Smug Sweaters Ltd

Telipara, Gazipur
(23.997564N ,90.382987E)

15 December 2013

Building Observations

Load Management

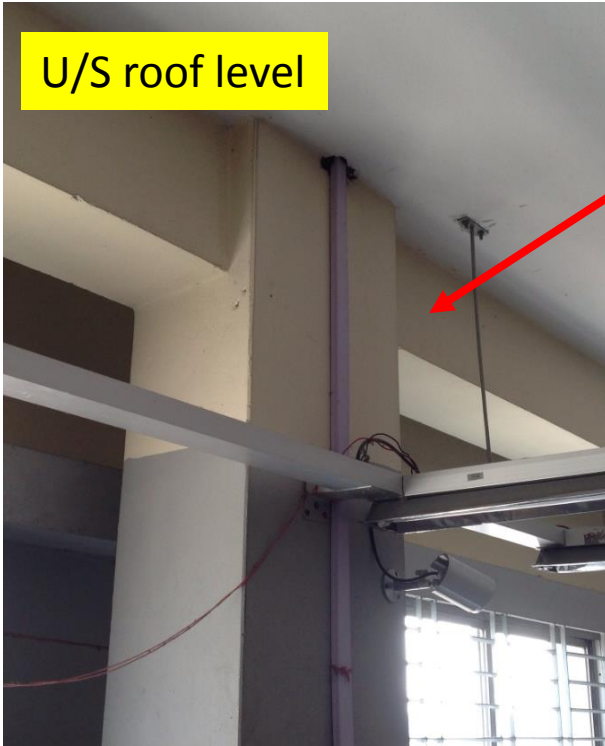
Limit density of loading in storage areas

**Uncontrolled
loading**

**Plan and height restrictions to be introduced to prevent future overloading.
(Loading plans in line with design loads from engineer)**

**Structural drawings not matching as built
condition (minor)**

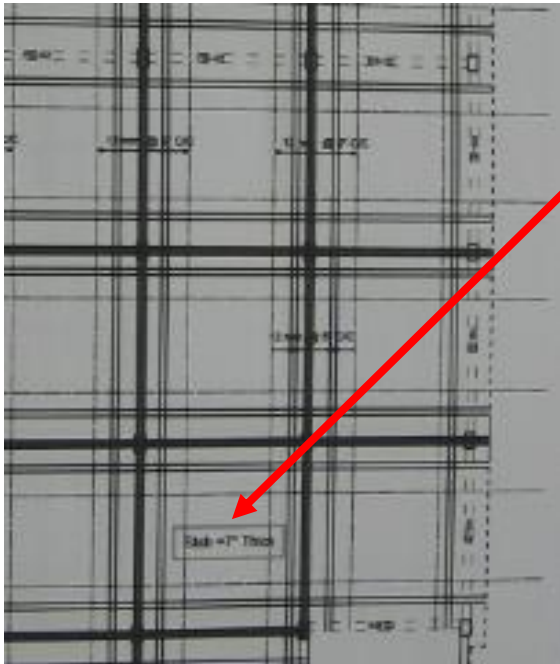
Edge beam shown on drawings at underside of roof (6th floor) but also present at underside of 4th floor

Structural drawings not matching as built

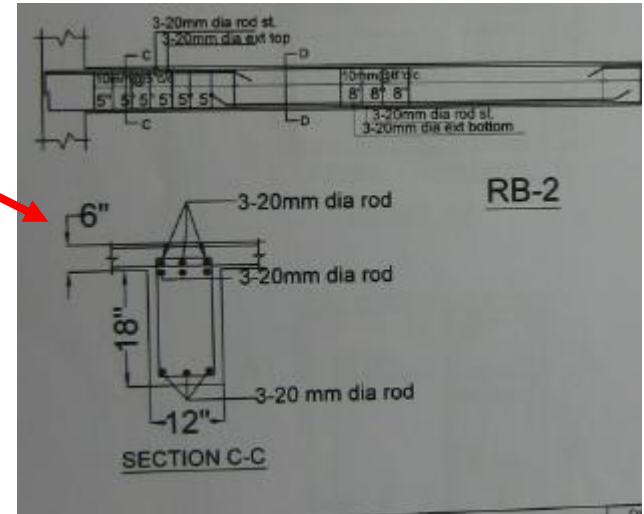
Roof slab shown as 7" on structural floor plans and 6" in roof beam sections. Roof slab appeared to be more active when jump test done. Thickness to be confirmed by engineer
